ECONOMISER ASSEMBLY

DRG NO : EC-15-GA-001

BOM CHECK SUMMARY

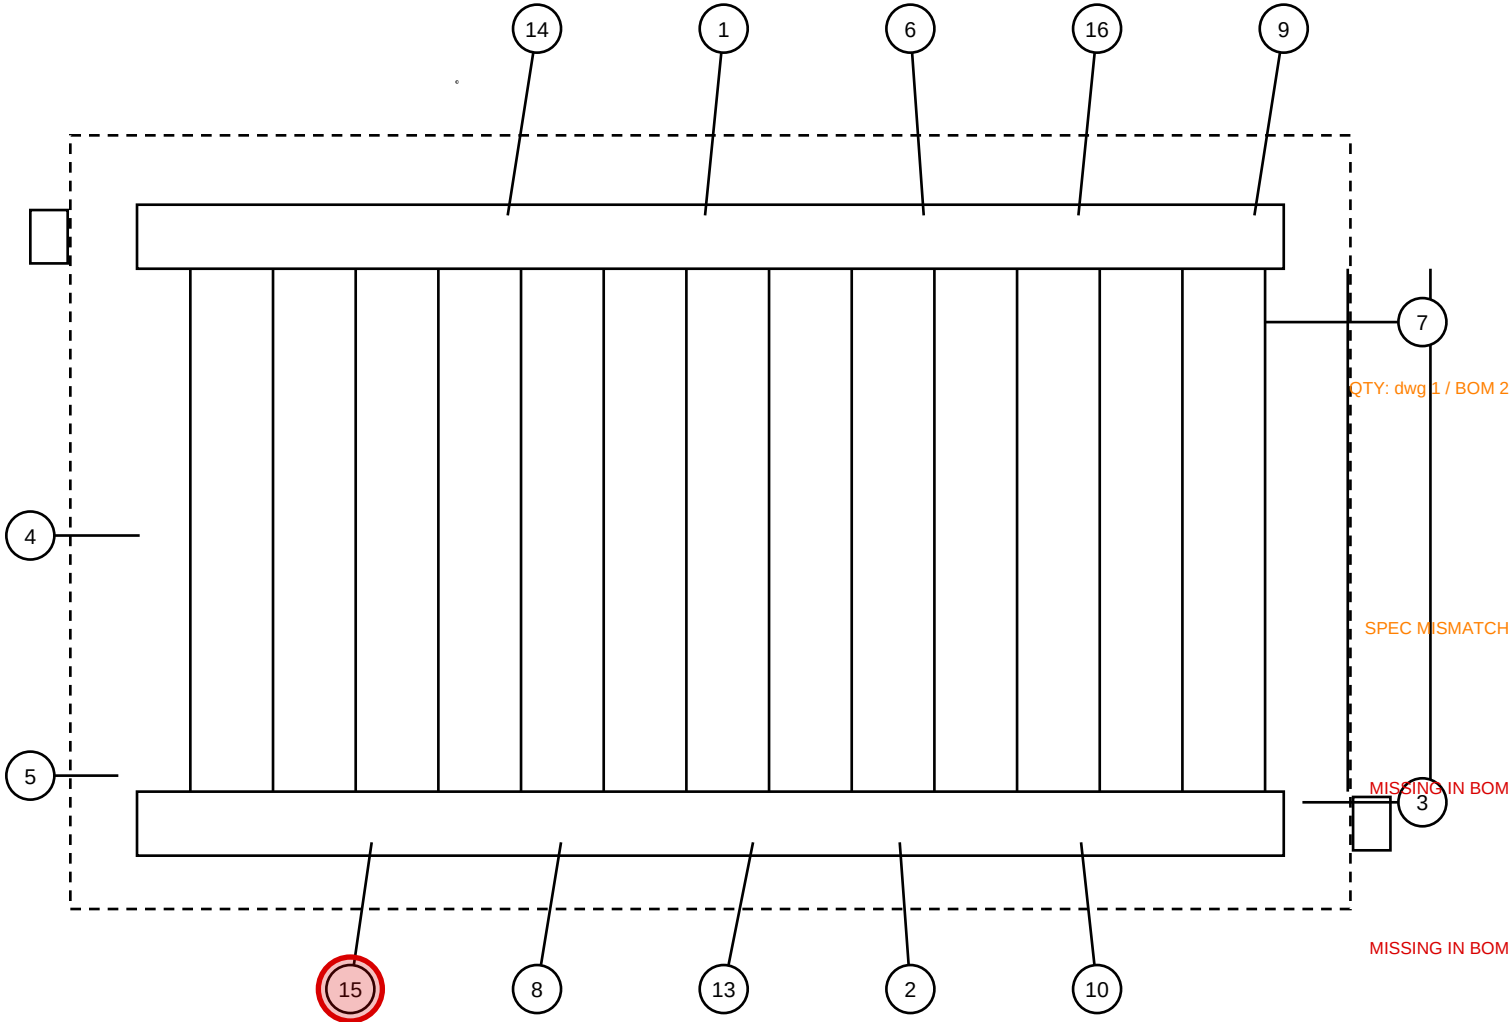
Findings: extra 1, omission 2, quantity 1, revision 1, spec 1

[RED] Item 11 'GASKET 200 NB CL.150' (qty 2) is on the drawing but has no BOM line
[RED] Item 15 'NAME PLATE' (qty 1) is on the drawing but has no BOM line
[ORANGE] Item 1: quantity differs (drawing 1, BOM 2)
[ORANGE] Item 7: specification mismatch - dimension: drawing ['200'] vs BOM ['250']
[ORANGE] Revision mismatch: drawing is Rev C, BOM is Rev B
[YELLOW] BOM row 23 'Hand rail, 42 NB' has no matching item on the drawing (extra, or from another revision)
